Your starting layout: what to keep, what to improve

Reference: your supplied screenshot. Colours in KiCad do not establish a copper zone's electrical net.

Recommended floorplan

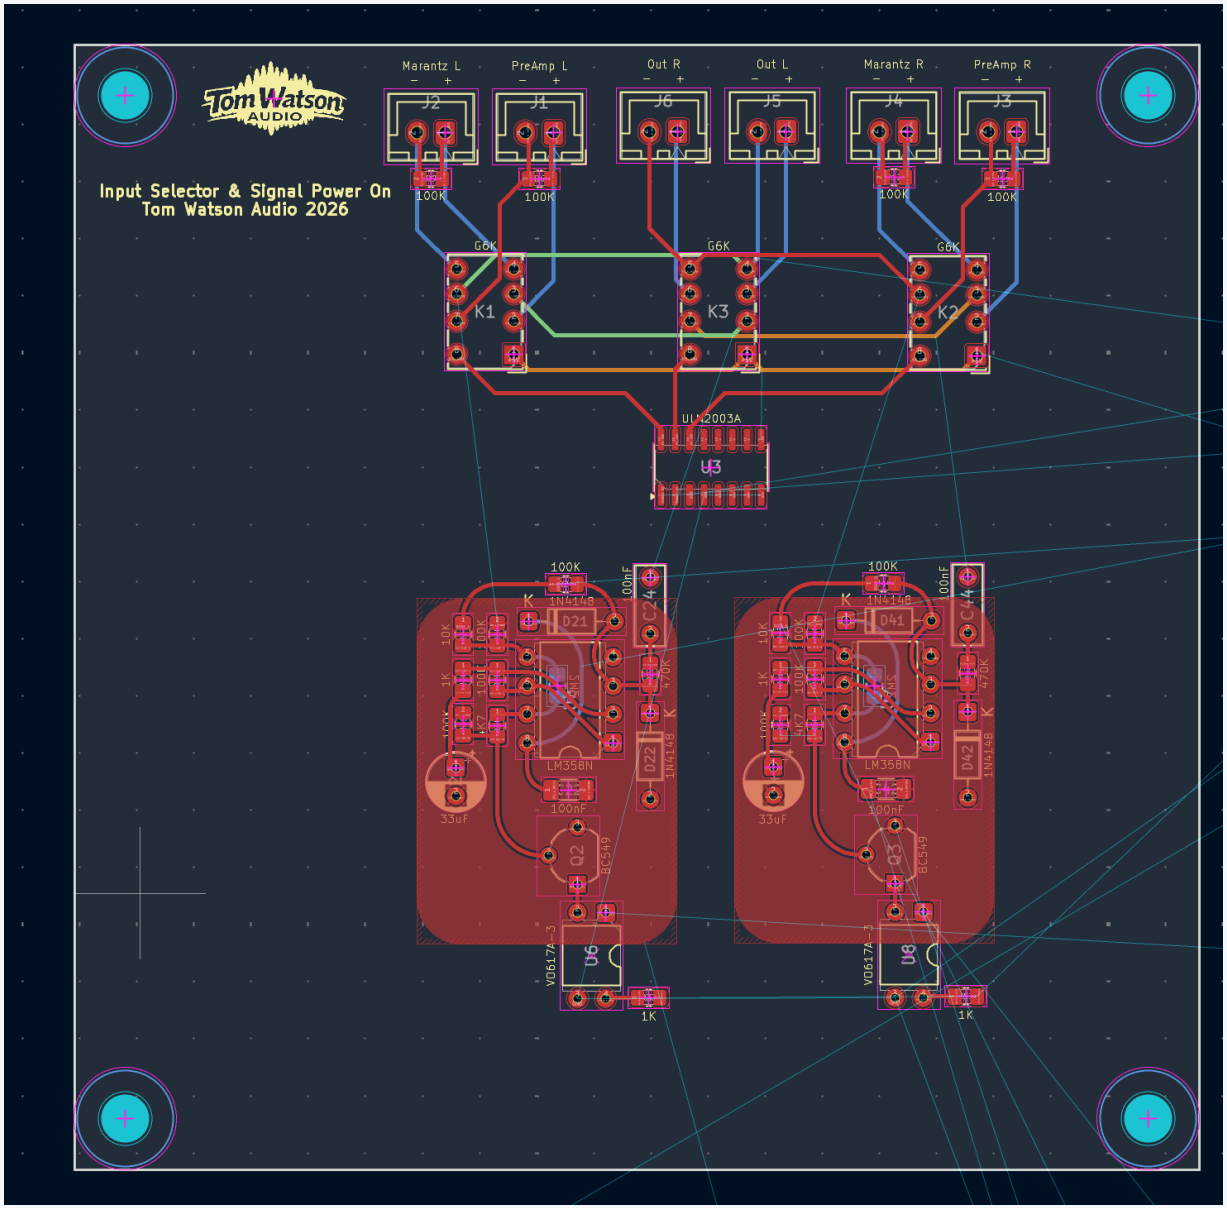
KEEP: audio along the top

Connectors and K1/K2/K3 belong together. Keep each signal beside its own return; minimise the through path and the area enclosed by that pair.

KEEP: two compact detector blocks

Place each detector below its selector. A short sensing branch is useful, but keeping the high-impedance node at LM358 pin 3 tiny matters more than exact left/right symmetry.

IMPROVE: coil-current corridor

U3 below the relays is sensible. Route coil supply, switched coil leads and their control return below/around the contact wiring. Avoid long parallel runs beside audio traces.

CHECK: local decoupling

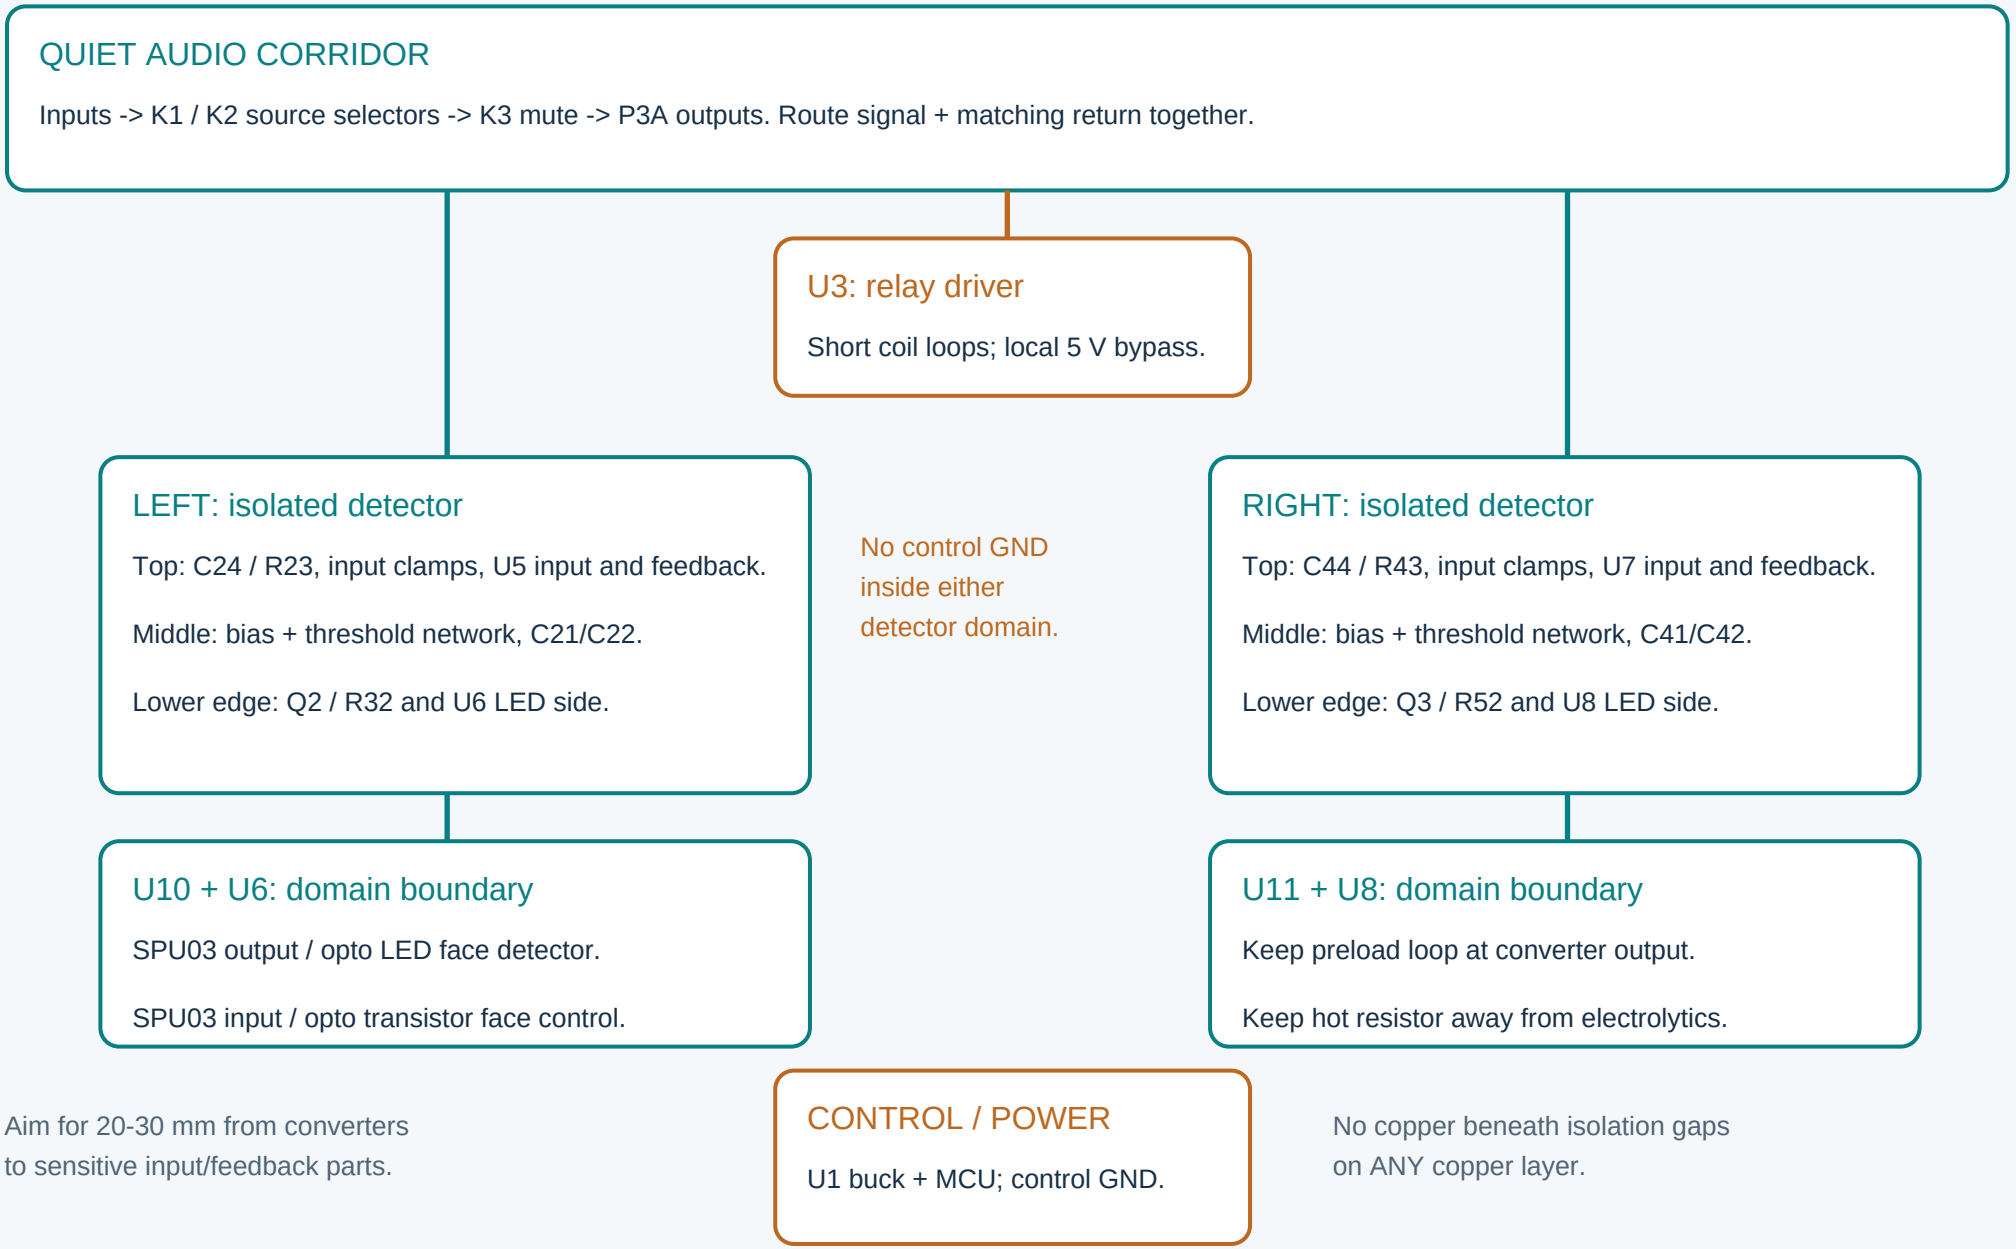
The 100 nF parts below the LM358s deserve attention: locate C22/C42 at pin 8, with a short return to pin 4/local return copper. Component proximity alone is not enough.

RESERVE: lower edge for power

Keep the buck, SPU03 modules and preload resistors out of the audio corridor. Let the converters straddle the boundary between control and isolated detector domains.
